STAFF RECOMMENDATION
102 South 17th Street
August 16, 2017

Application: New construction—addition; Setback determination
District: Lockeland Springs-East End Neighborhood Conservation Zoning Overlay
Council District: 06
Map and Parcel Number: 08310022300
Applicant: Jason Feller
Project Lead: Melissa Baldock, melissa.baldock@nashville.gov

Description of Project: Application is the construct an addition that is wider than the historic house. The addition requires a change in the rear setback from twenty feet (20') to sixteen feet, six inches (16'6").

Figure 6. The 1957 Sanborn map, shown here, and the 1951 Sanborn Map both show the rear extension as a porch.

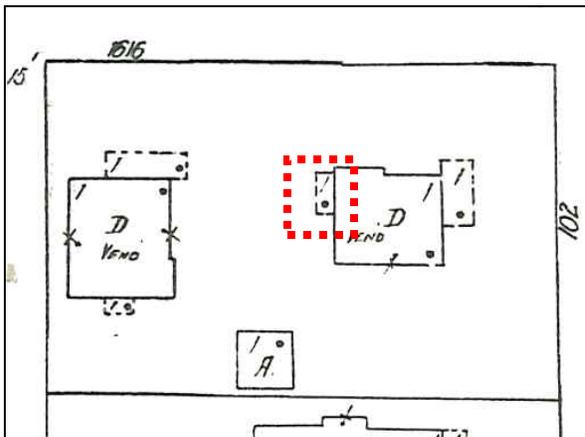
The date of construction for the rear extension is unknown. It does appear as part of the house in the 1951 and 1957 Sanborn Maps as a porch (Figure 6). Staff finds that the extension's separate roof form, separate materials, and its design do not contribute to the historic character of the historic house, nor to the overall Lockeland-Springs neighborhood.

Staff finds the rear dormer and rear extension do not contribute to the architectural and historical character and significance of the house or Lockeland Springs district. Staff further finds that their demolition meets Section III.B.2 for appropriate demolition and does not meet section III.B.1 for inappropriate demolition.

3 Site Plan - Existing
1" = 30'-0"

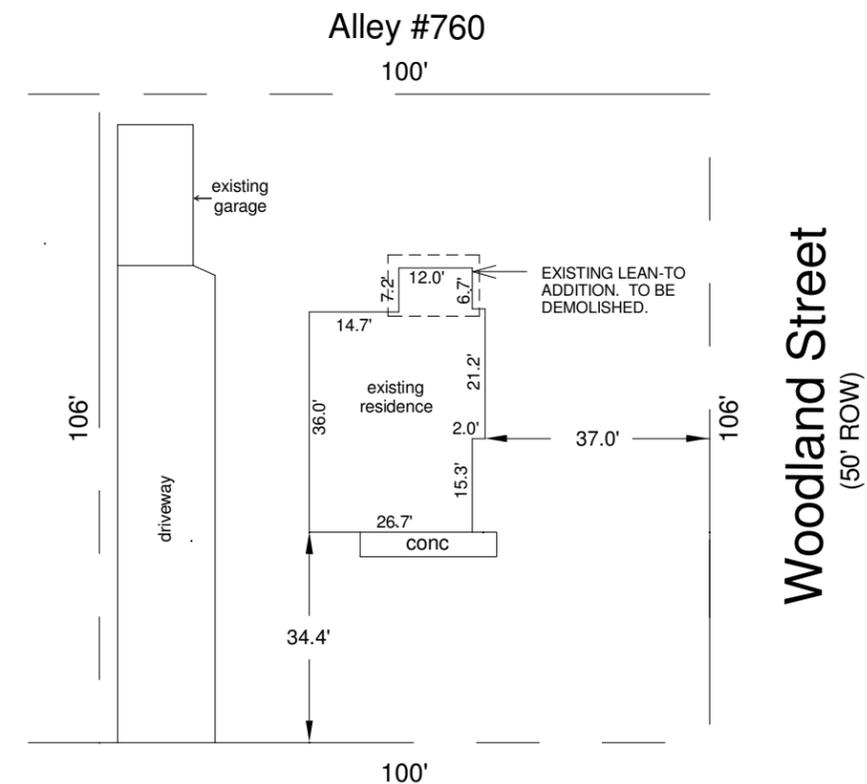
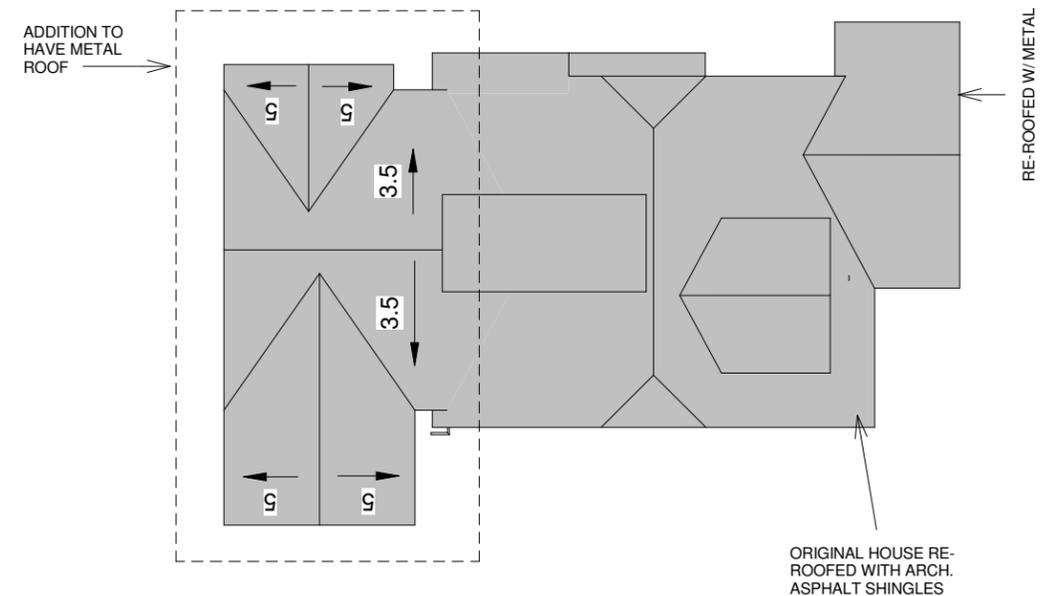
Setbacks: The proposed addition meets the base zoning side setbacks. It will be thirty-eight feet (38’) from the right/Woodland Street property line and twenty-five feet (25’) from the left side property line. The addition will not meet the twenty foot (20’) rear setback required by base zoning. The addition is proposed to be sixteen feet, six inches (16’6”) from the rear property line. In other words, the addition is proposed to encroach three feet, six inches (3’6”) into the rear setback.

Staff finds the proposed rear setback to be appropriate because the lot is unusually shallow and the addition’s depth is relatively modest in scale. The lot is one hundred and six feet (106’) deep, which is fifty feet (50’) shallower than the other lots that face South 17th Street. The proposed addition is just eighteen feet, three inches (18’3”) deep, which is not overly large. The addition will encroach just three feet, six inches (3’6”) into the rear setback line, which will not visually impact the rhythm of spacing along Woodland Street and will allow for sufficient space in between the back of the addition and the side wall of the neighboring house at 1616 Woodland Street.

Staff finds that the proposed setbacks, and the rear setback determination meet Sections II.B.3. and II.B.10. of the design guidelines.

2 Copy of Roof Plan
1/16" = 1'-0"

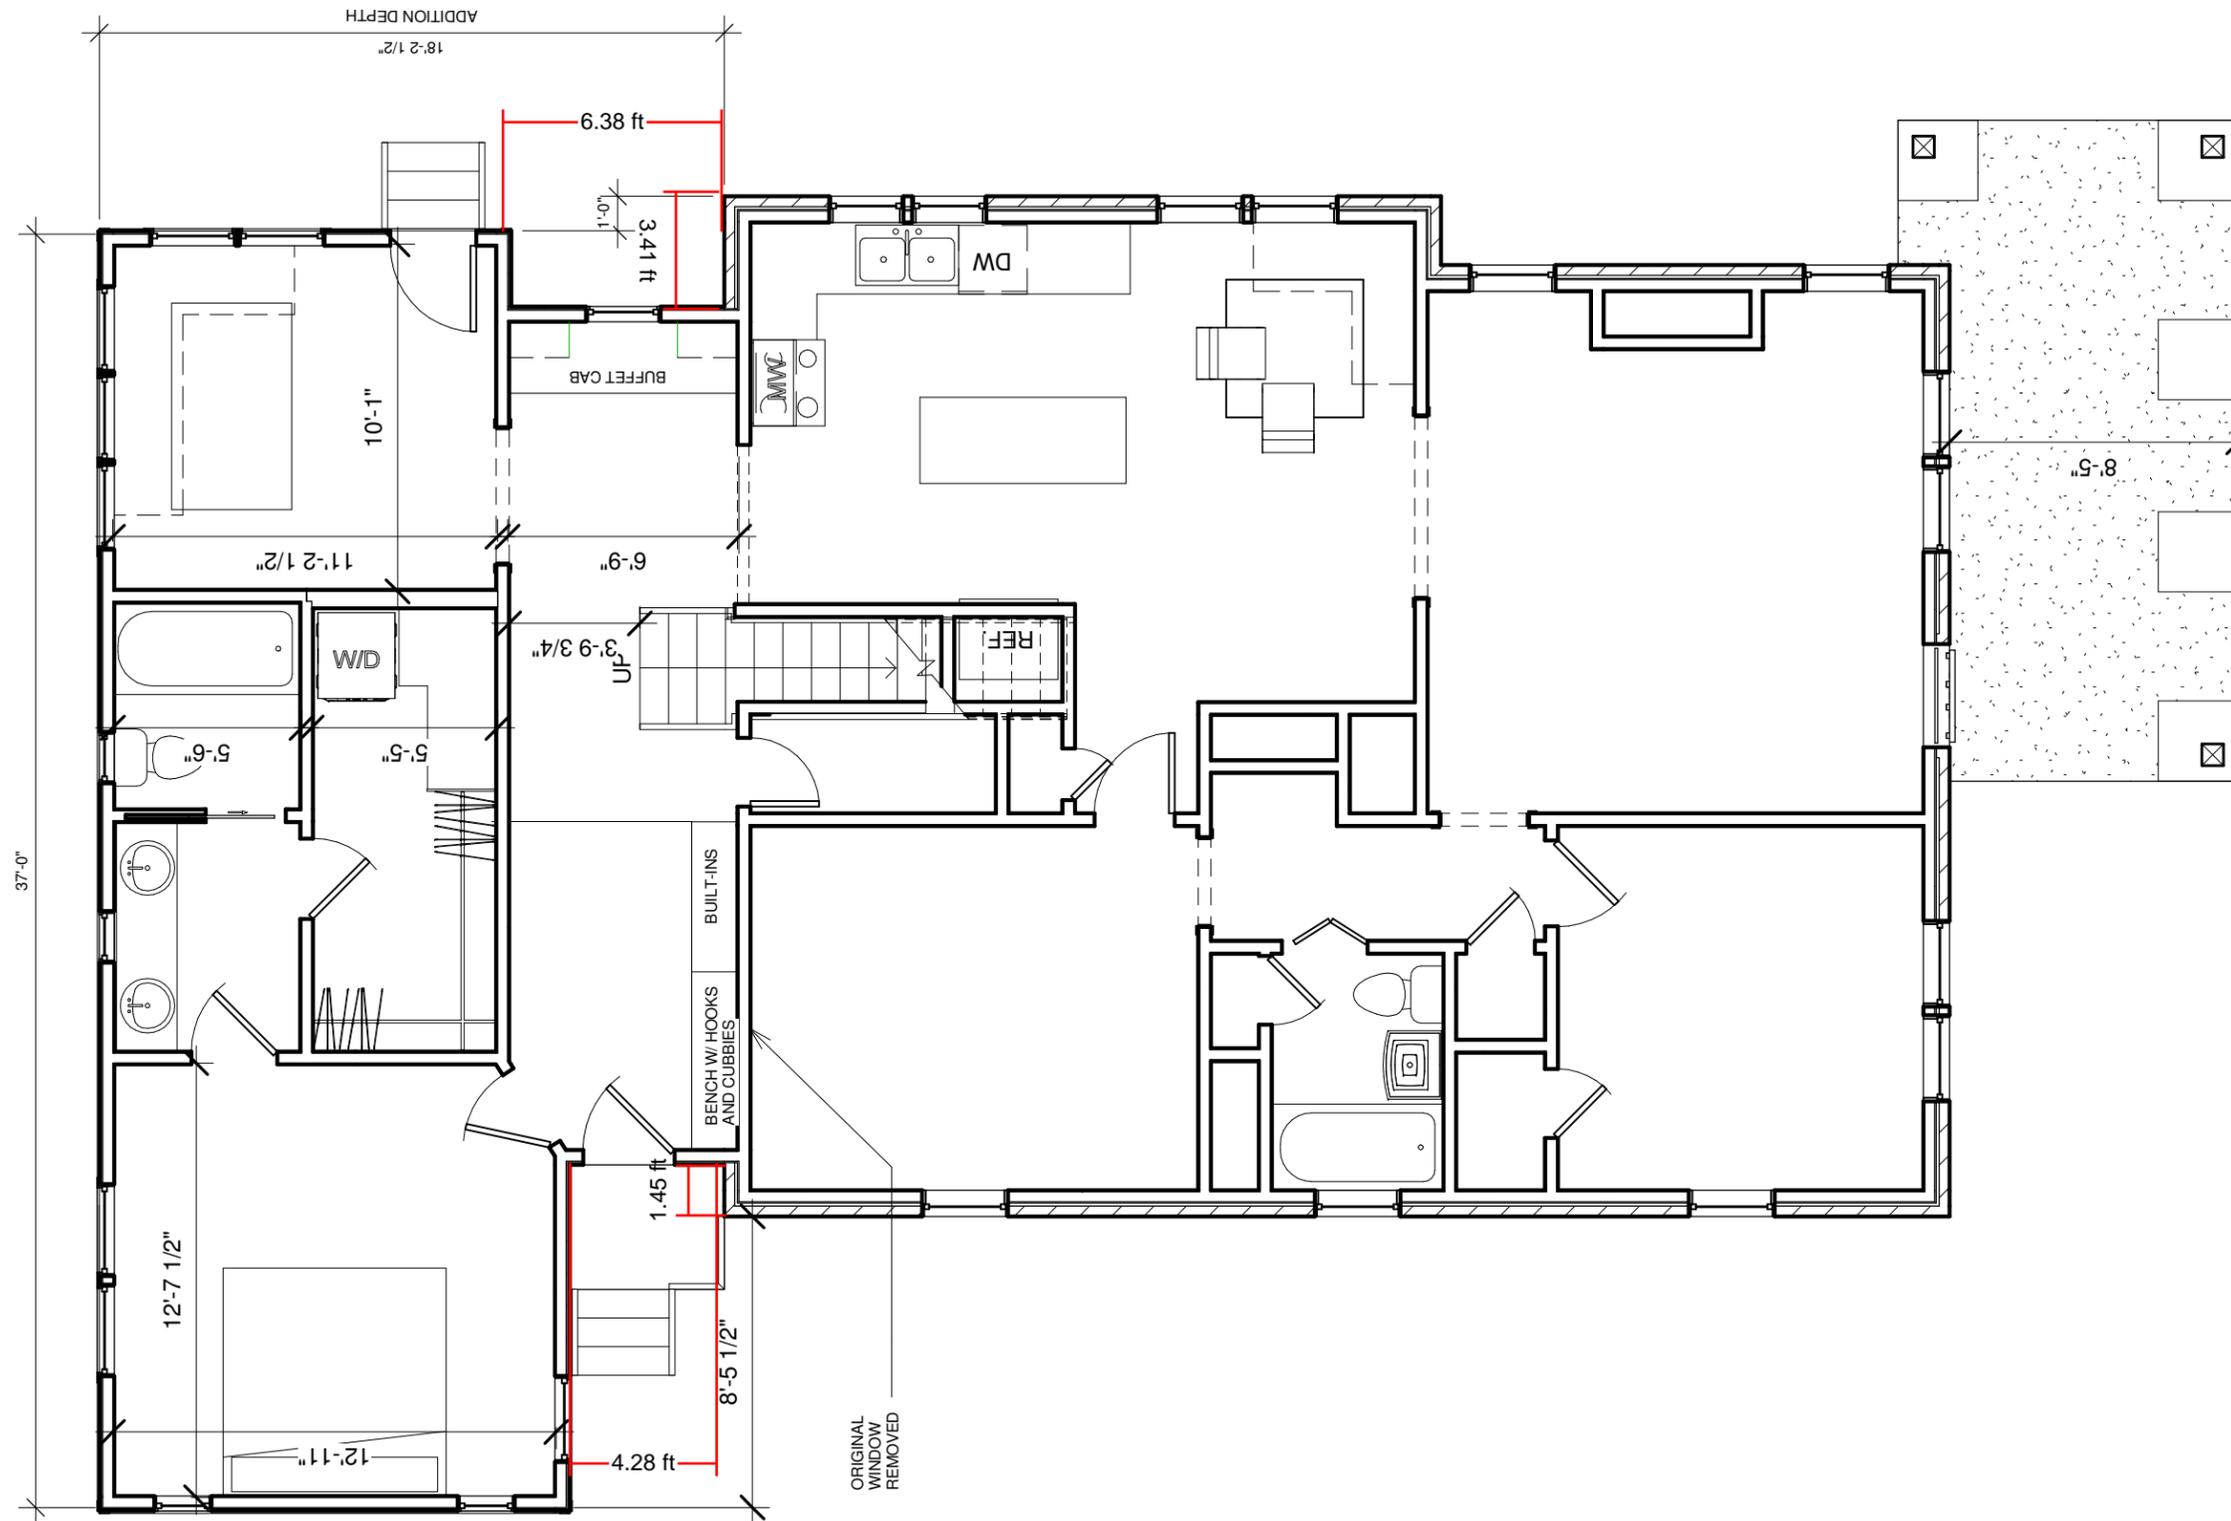
Roof form: The rear dormer will have a shed roof form with a 3/12 slope. The dormer is set off the ridge a minimum of six inches (6”) and is inset from the side walls of the historic by more than twelve feet (12’) on both sides. The one-story addition will tie into the back of the historic house with a 3.5/12 gable, and the main form of the roof will have a 5/12 side gable. The design guidelines states that new construction should generally have roof slopes with a minimum pitch of 6/12. Staff finds the lower 5/12 pitch to be appropriate for several reasons. The addition is modestly scaled in both height and footprint. Moreover, the historic house has a roof pitch at 7/12, and a 5/12 pitch is compatible with the historic house’s 7/12 pitch . For these reasons, staff finds that the proposed roof form meets Sections II.B.5. and II.B.10. of the design guidelines.

ELEVATIONS		H3
Date	7/31/17	
Drawn by	J. Feller	Scale 3/16" = 1'-0"

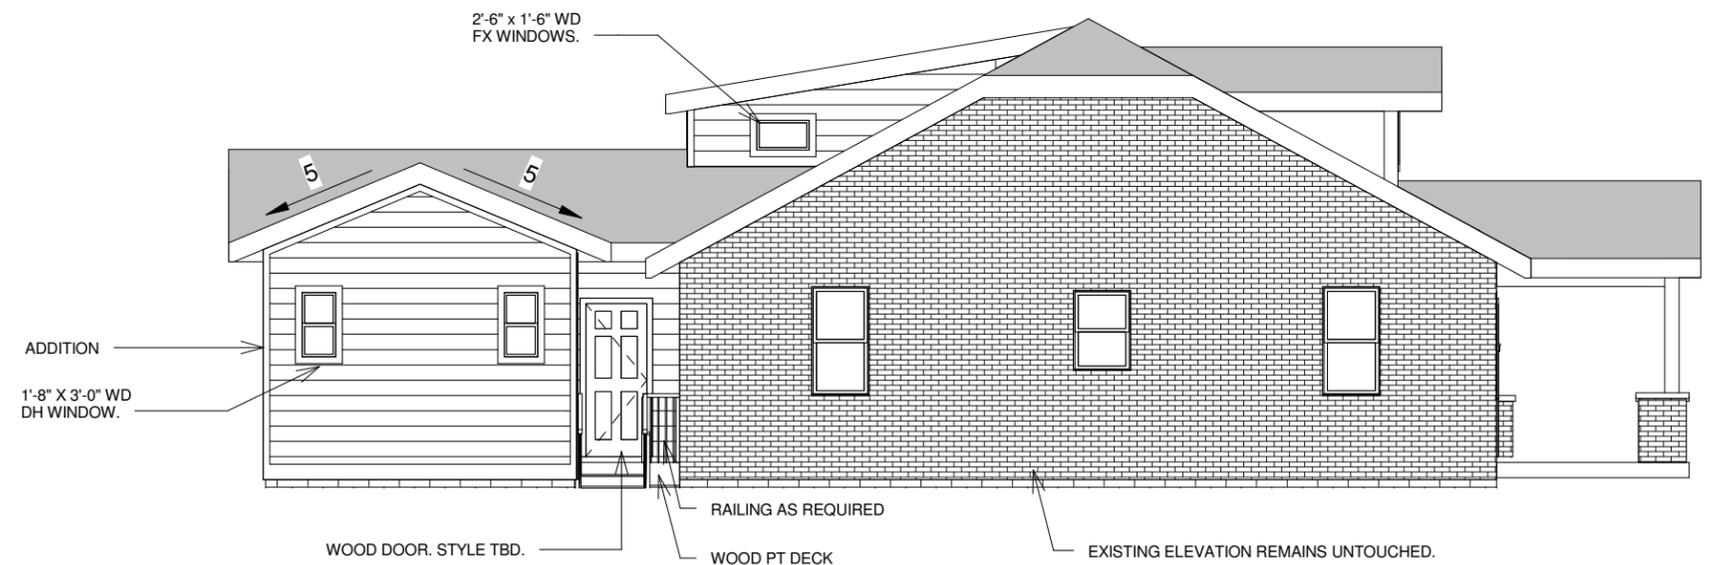
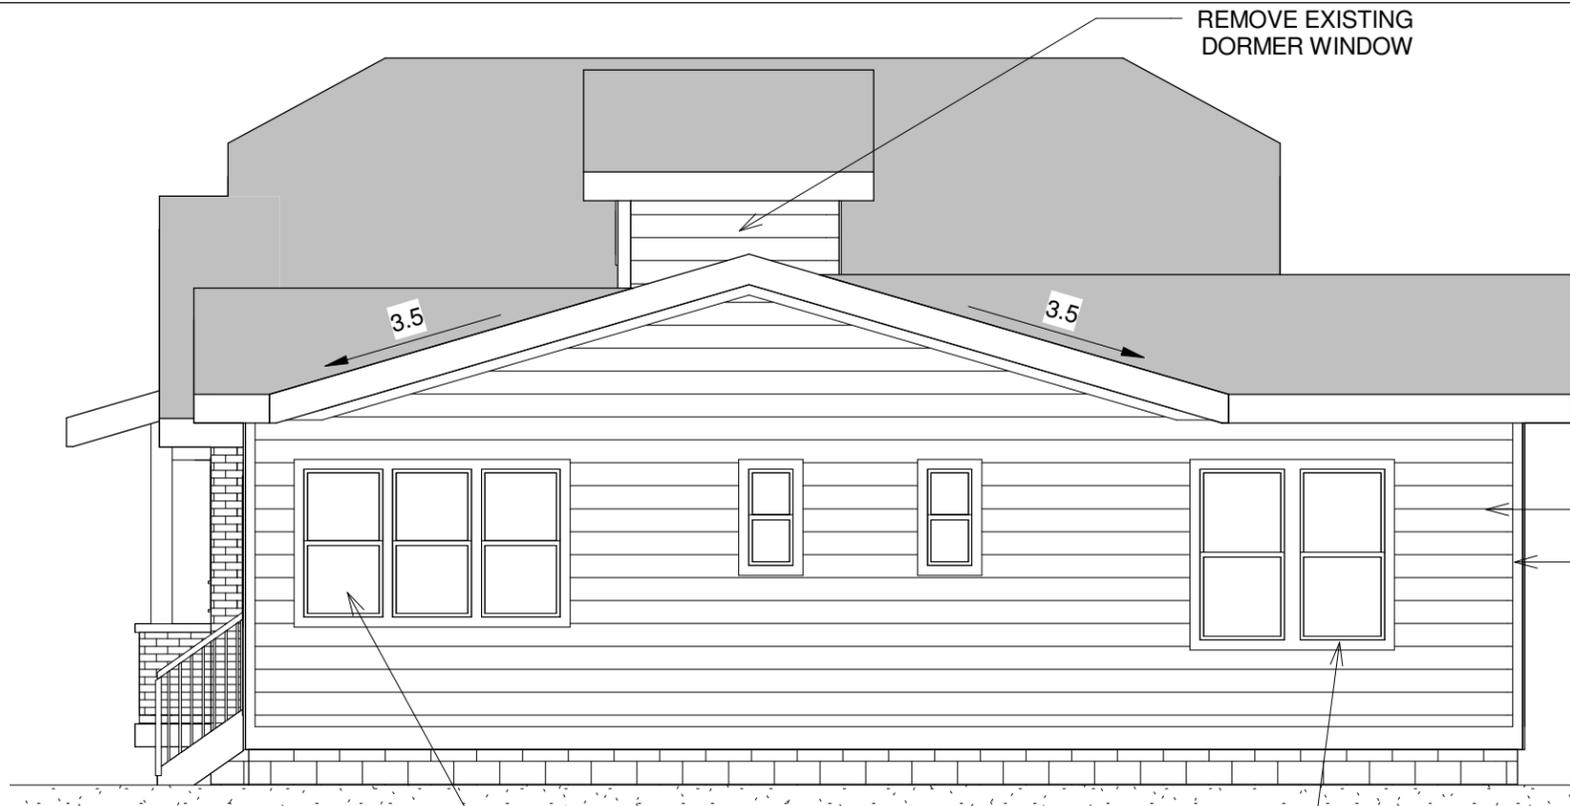
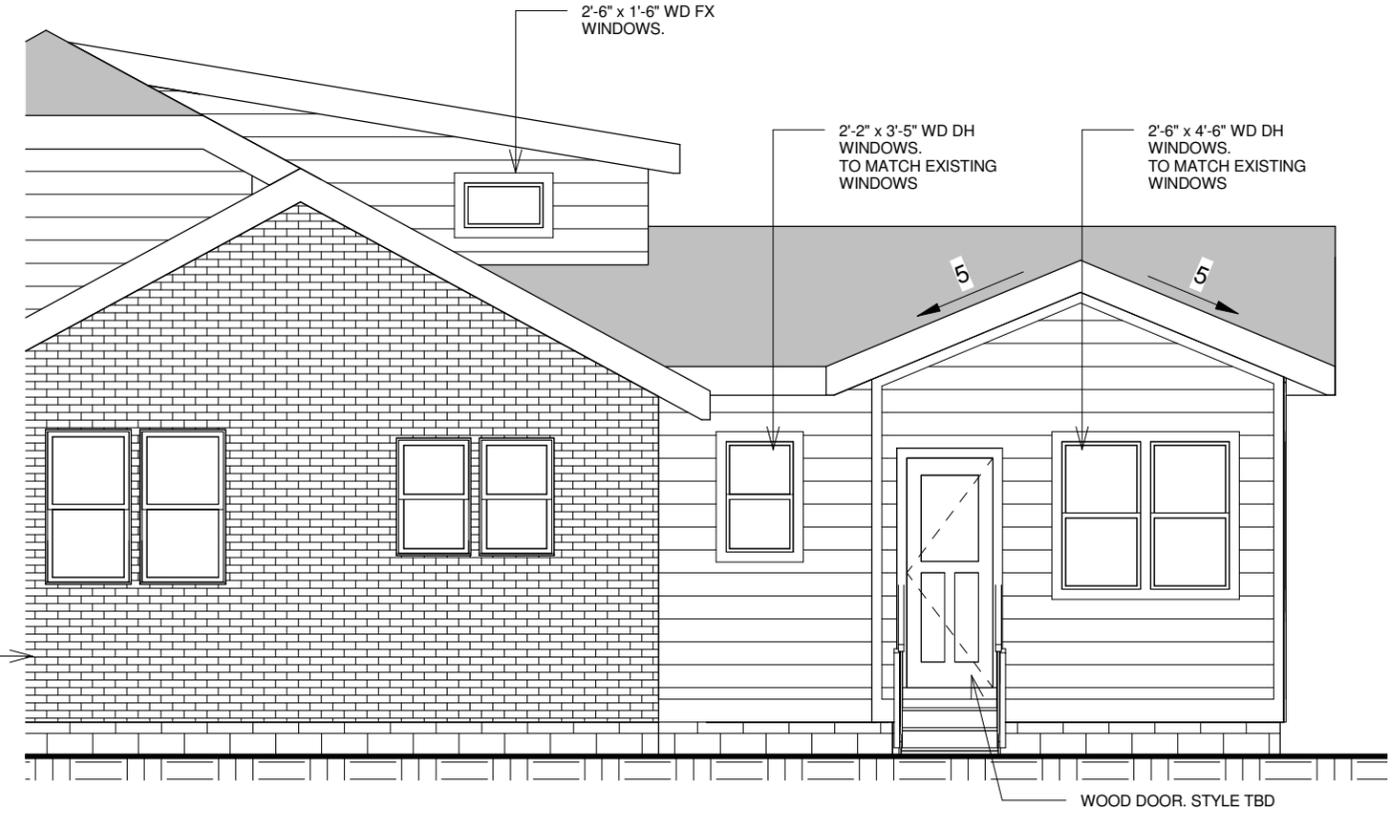
Height & Scale: The existing historic house is one-and-a-half stories. The proposed addition will be one-story in height, with an eave height of ten feet, six inches (10'6") and a ridge height of fifteen feet (15'). The addition will be over six feet (6') shorter than the historic house. A new rear dormer will replace the existing dormer. It will be set a minimum of six inches (6") off the historic roof and will be inset well over two feet (2') from the side walls of the historic house.

Proportion and Rhythm of Openings: No changes to the window and door openings on the existing house were indicated on the plans. The windows on the proposed addition are all generally twice as tall as they are wide, thereby meeting the historic proportions of openings. There are no large expanses of wall space without a window or door opening. Staff finds the project’s proportion and rhythm of openings to meet Sections II.B.7. and II.B.10. of the design guidelines.

2. Staff approve the final details, dimensions and materials of windows and doors prior to purchase and installation;
3. Staff approve the metal roof color and the asphalt shingle color; and
4. The HVAC shall be located behind the house or on either side, beyond the mid-point of the house.
